## 5 Requirements for NG-EPON

### 5.12 Service ~~Profiles~~Types

Figure 524: Architecture of public WiFi backhaul service

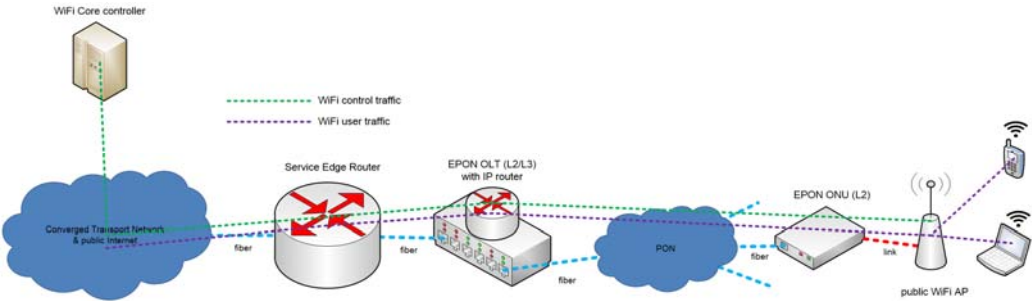
Commented [MH2]: Added to clarify where the IP address comes from

During the initialization phase, the WiFi AP either retrieves an IP address from the default DHCP server or has its IP parameter preconfigured, and then establishes a communication path with the WiFi core controller. The said controller configures the WiFi AP with specific service parameters, including SSID, bandwidth profiles, and other parameters required for its proper operation. All the control and customer data is transmitted in-band across the public Internet.
